Proposed design changes following consultation:

WAIMAKARIRI ROAD

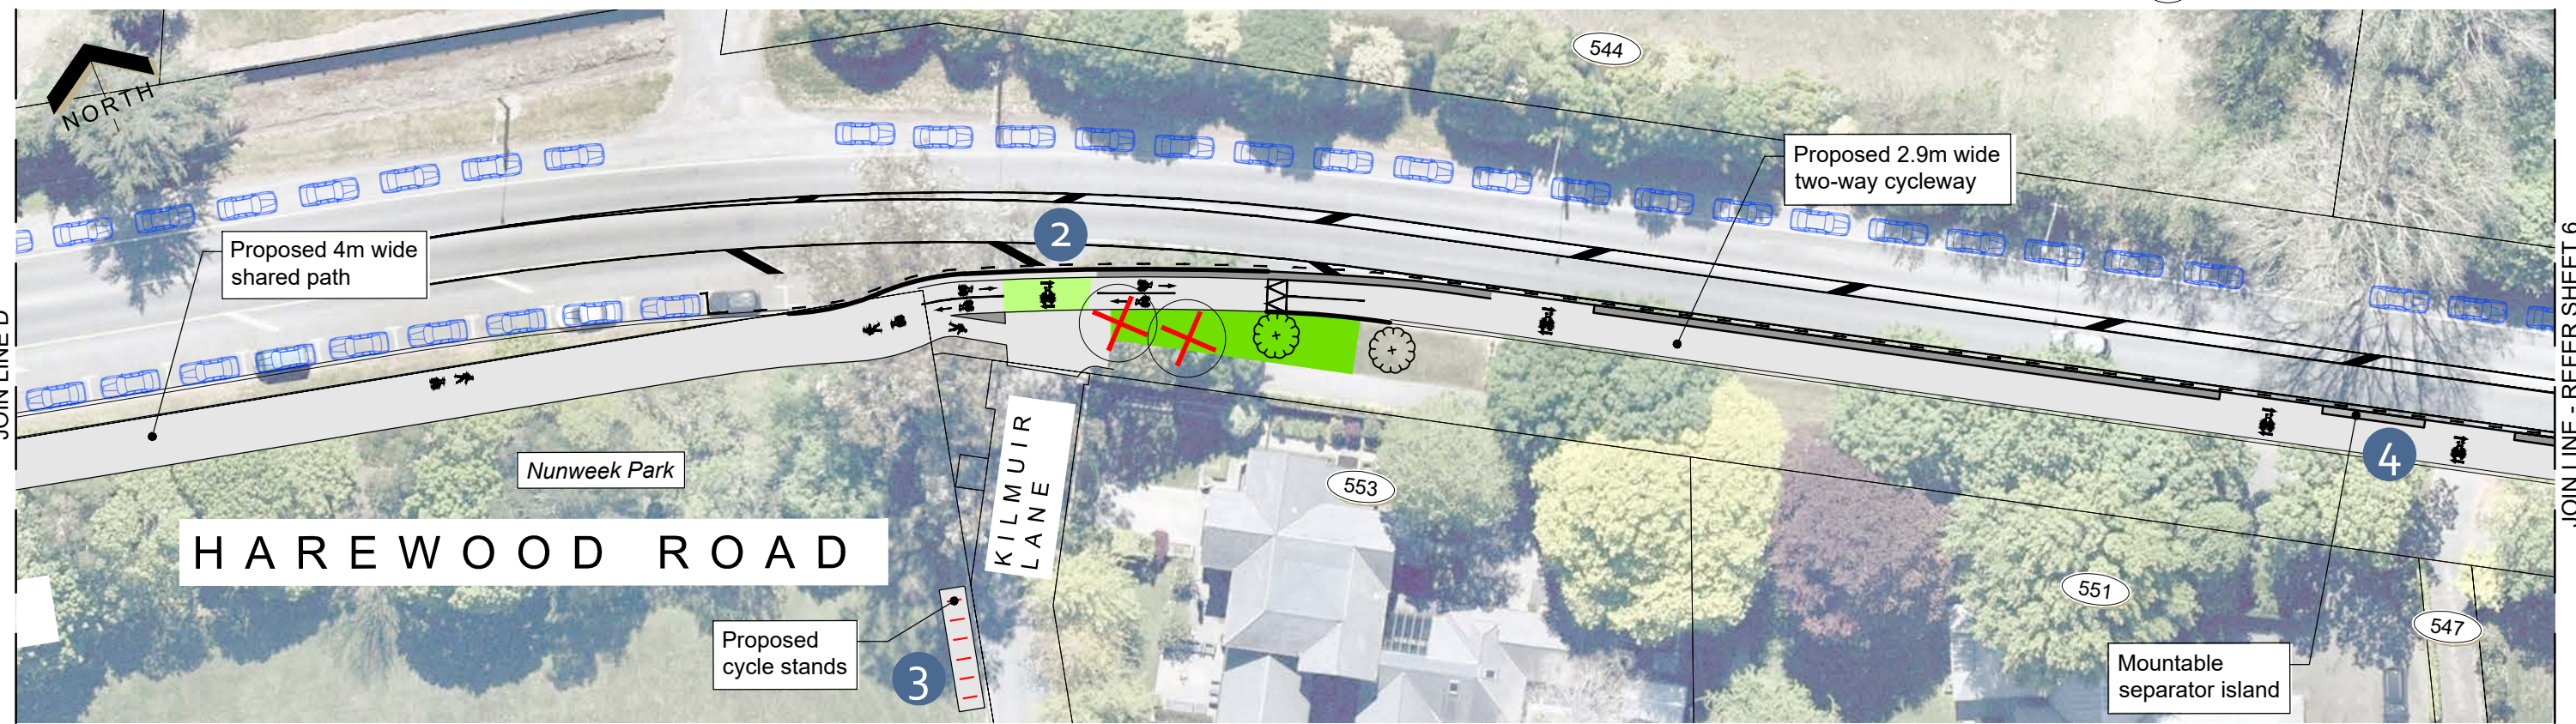
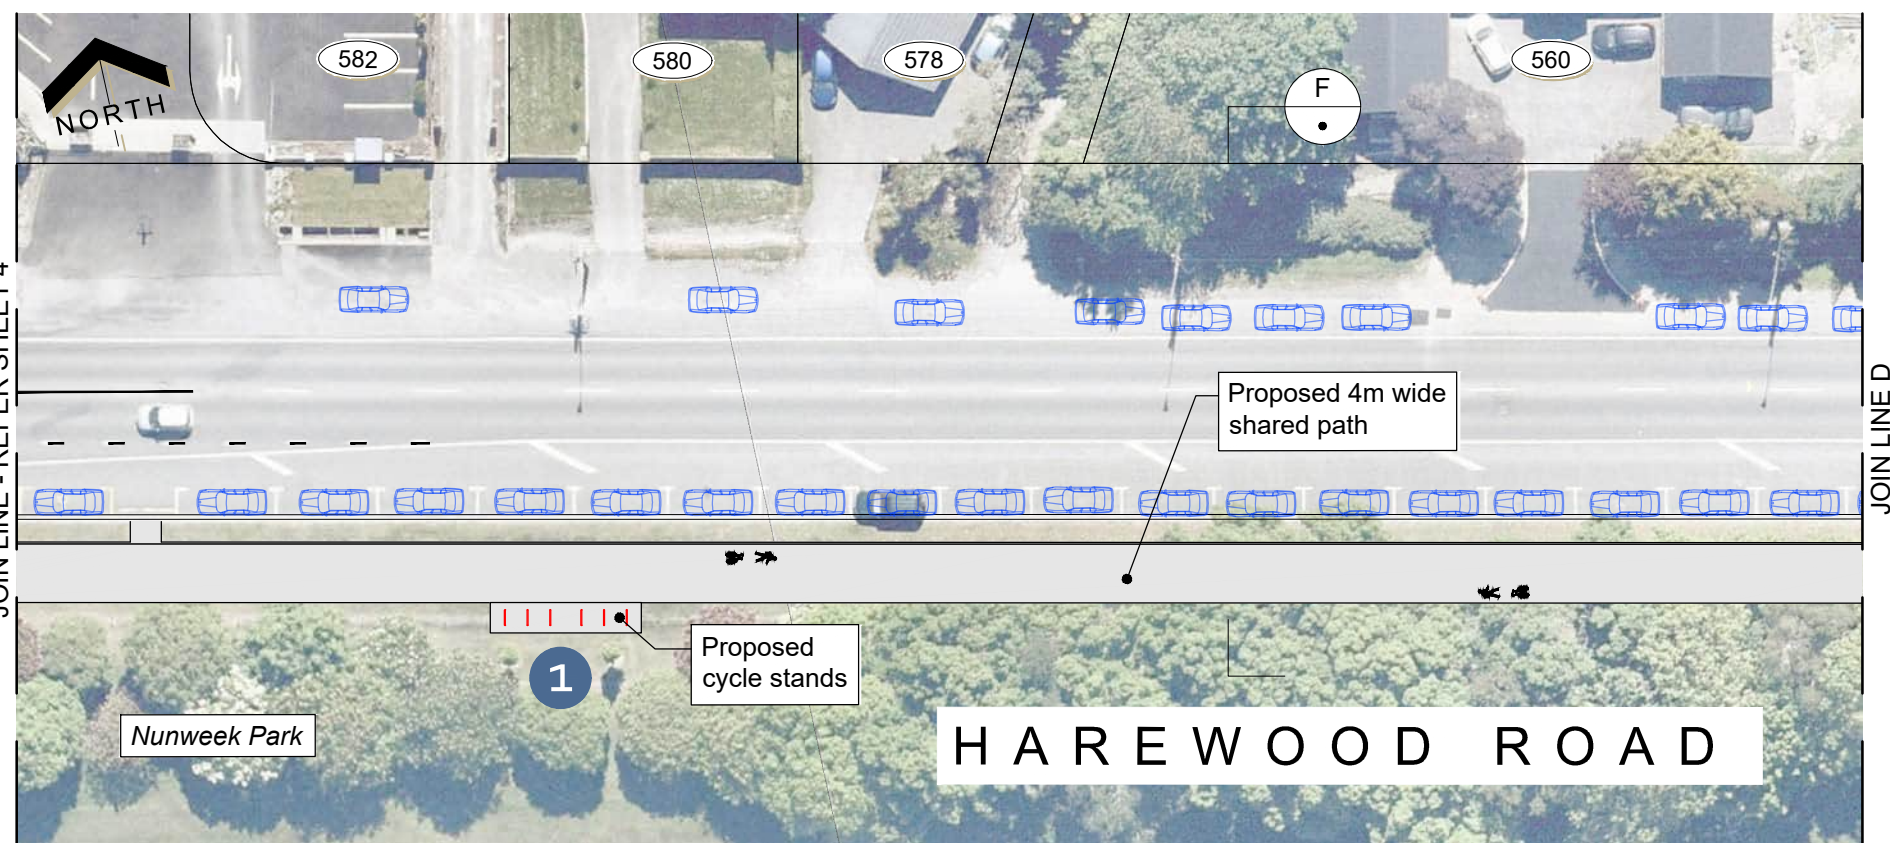
- Proposed design changes following consultation:**
- 1 Cycle stands are added outside Nunweek Park.
 - 2 The cycleway alignment is moved closer to the property boundaries to give drivers turning into Kilmuir Lane more space to wait clear of following traffic.
 - 3 Cycle stands are added near the playground.
 - 4 The section of cycleway separator between the driveways of No. 547 and No. 551 Harewood Road is made mountable.

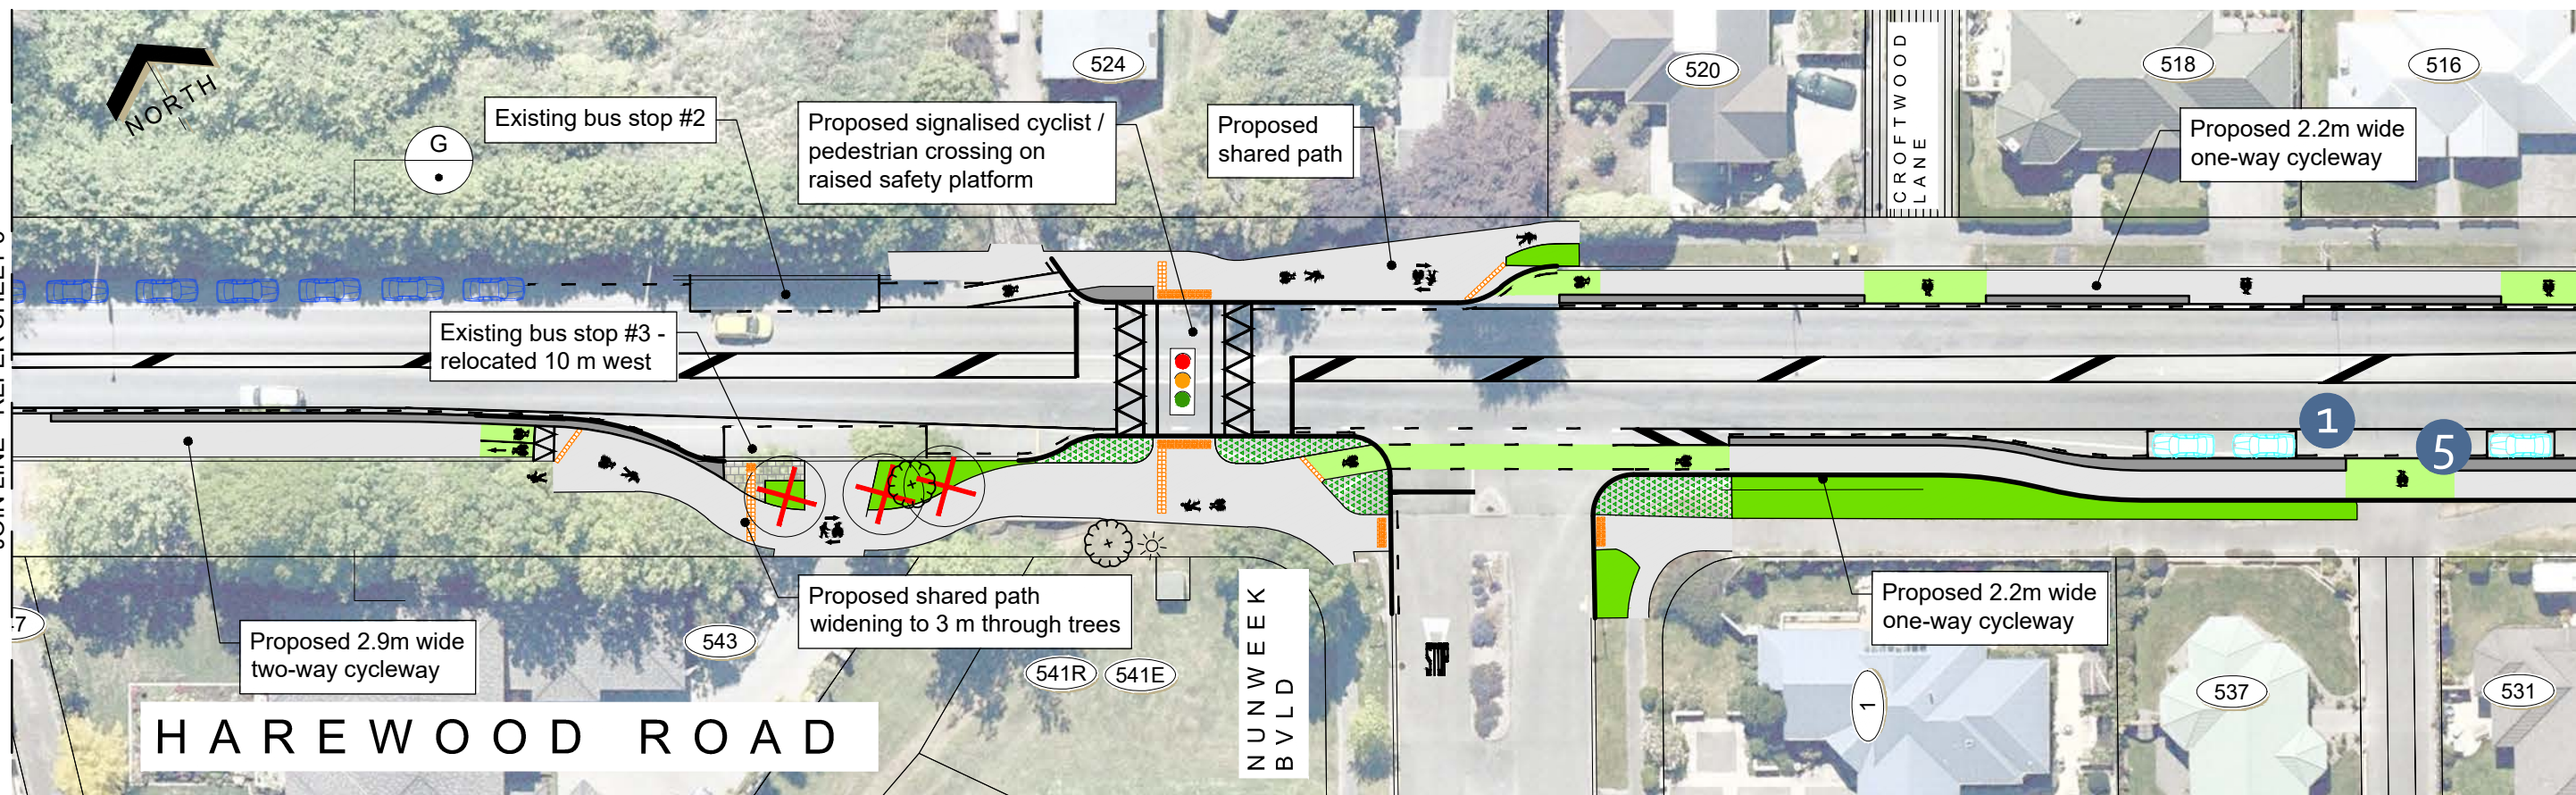
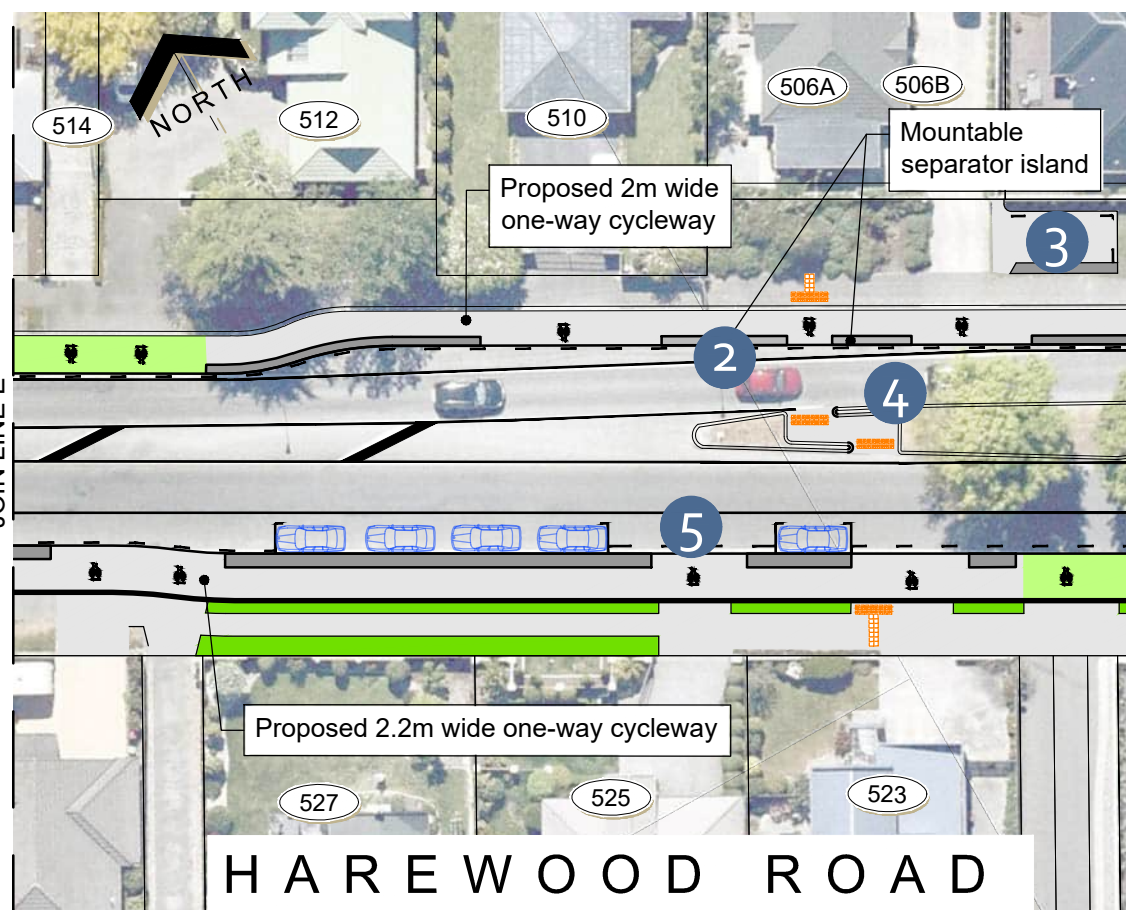
- 1 The cycleway separator is realigned and three on-street parking spaces are added.
- 2 The cycleway separator outside No. 506 is made mountable so that residents can drive over it when performing a U-turn to enter their driveway.
- 3 A turning area is added for residents of No. 506 who have less manoeuvre space due to the location of the central median island.
- 4 The crossing through the central median is widened to make it easier to use.
- 5 The openings in the cycleway separator at driveways between Nunweek Boulevard and the roundabout are increased to a minimum 5.5 m long.
